RAINBOW CREEK
BRIDGE

REFERENCE MILE 471 MACKENZIE HIGHWAY

DEPARTMENT OF PUBLIC WORKS
EDMONTON, CANADA

**BASIC ENVIRONMENTAL DATA
RAINBOW CREEK BRIDGE
REFERENCE MILE 471**

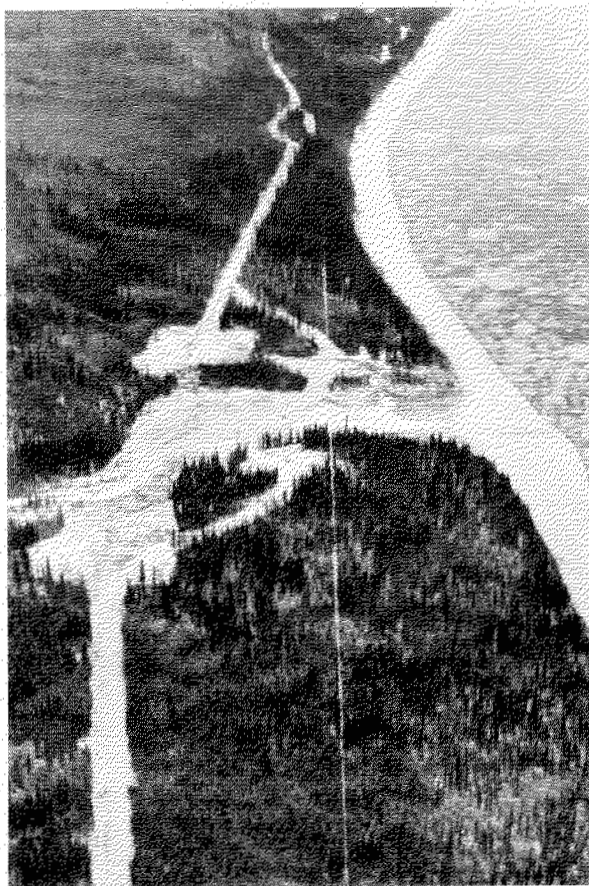
26.10.72. Rainbow Creek bridge crossing. Located on abandoned alluvial terrace. Both bridge design alternates encroach upon active channel and allow little room for movement of log debris. A single span would be more harmonious with physical conditions.

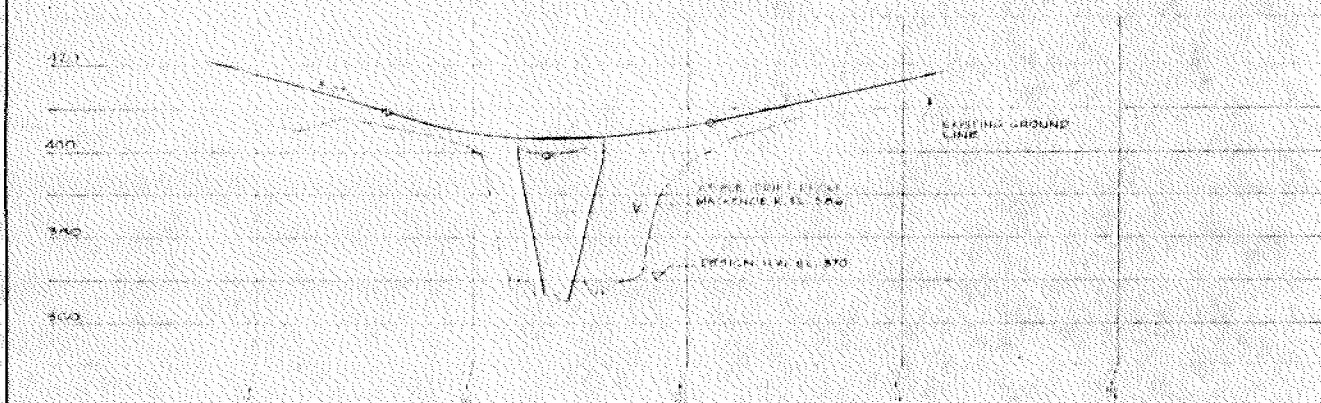
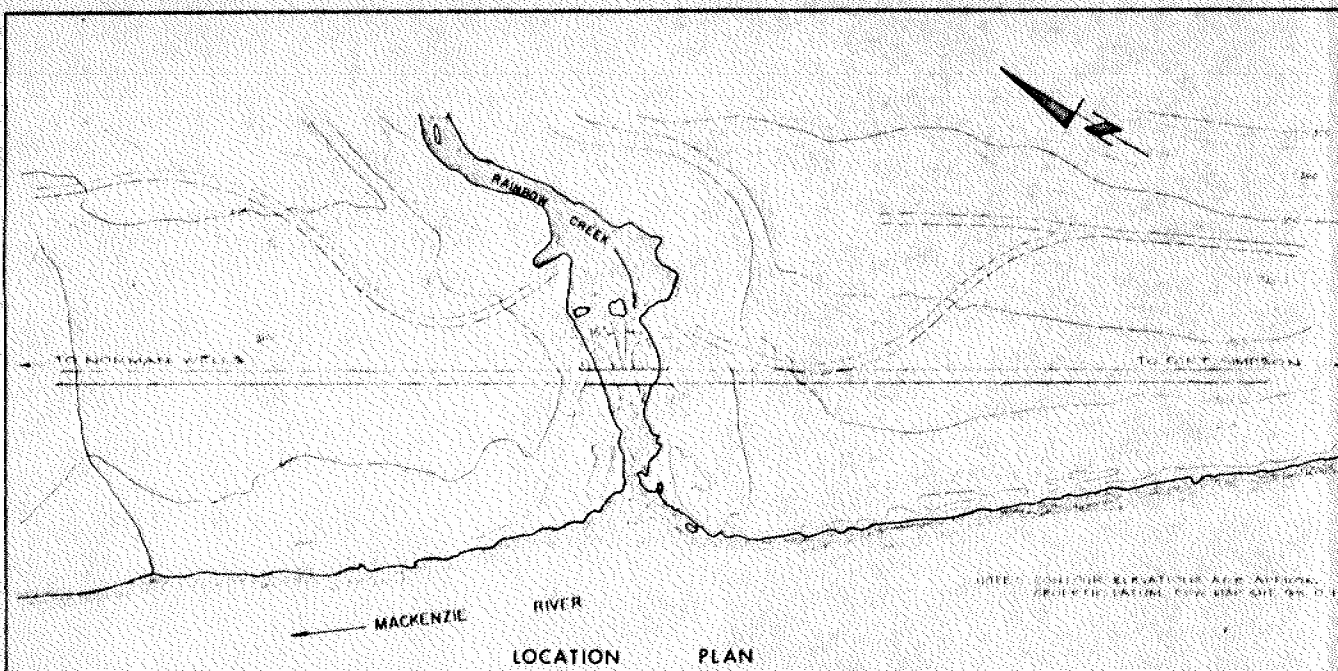
26.10.72. Rainbow Creek. Note location centerline in this photo. If the crossing has to be moved upstream against toe of scarp or onto scarp it will probably create siltation from unstable slopes. Existing cleared areas should be revegetated at the earliest possible date to minimize siltation from runoff; the stream is probably utilized by grayling and other species as spawning and rearing habitat. Vegetation is black and white spruce with some aspen. Soils are peaty gleysols and regosols.

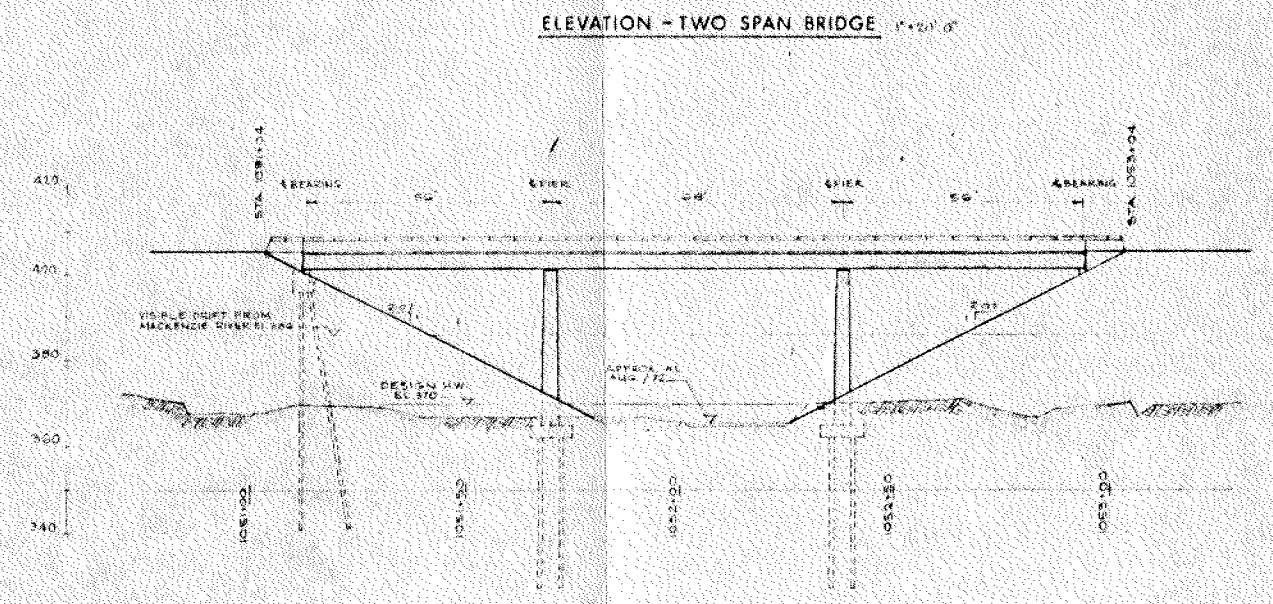
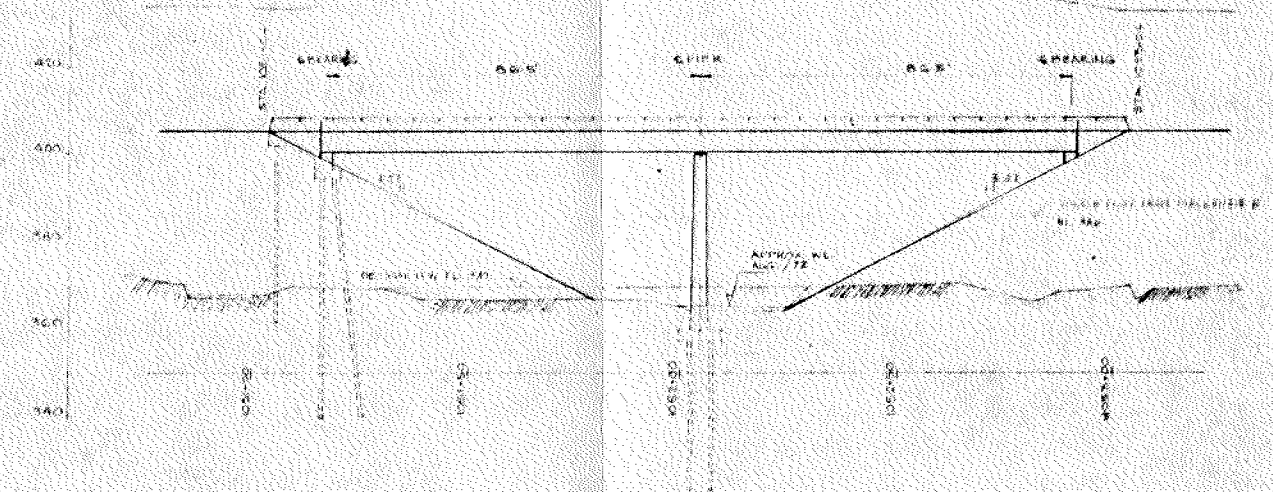
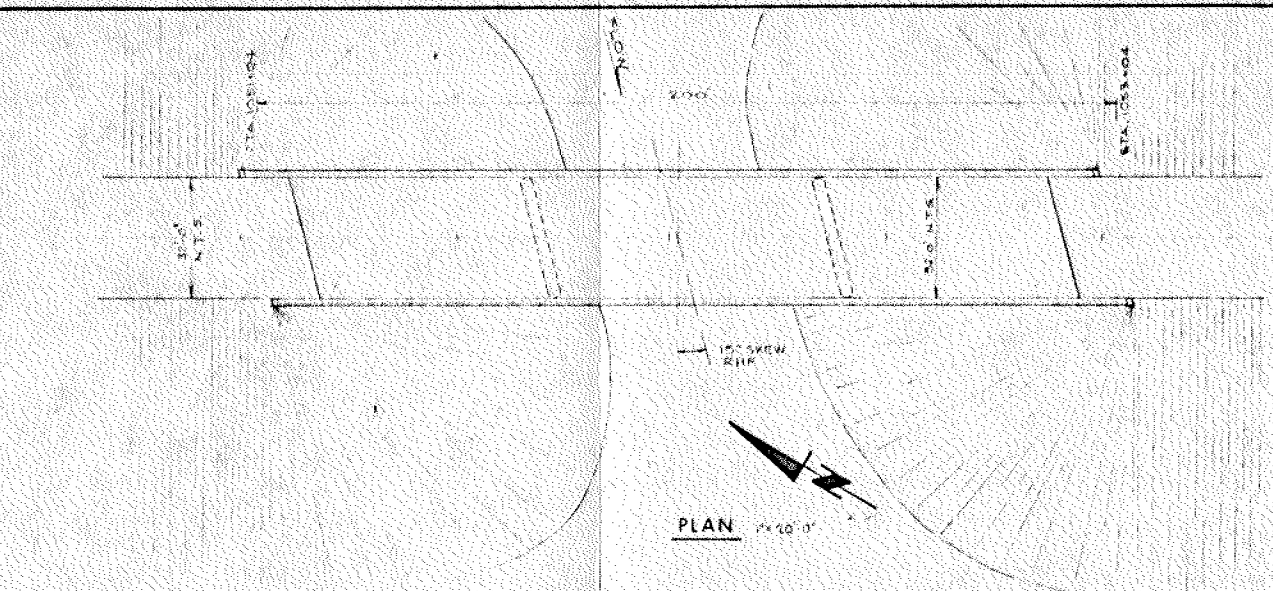
The fill for both bridge design alternates encroaches upon an active alluvial channel, and design allows minimum room for free passage of log debris. A single span would be more harmonious with expected conditions.

The encroachment of the approach fills on the stream bed appears excessive; stream velocities under the bridge should be calculated to ensure that barriers to fish are not developed.

Aesthetically this low bridge and fill does not lend itself to much improvement. The single pier bridge is the more attractive alternative.
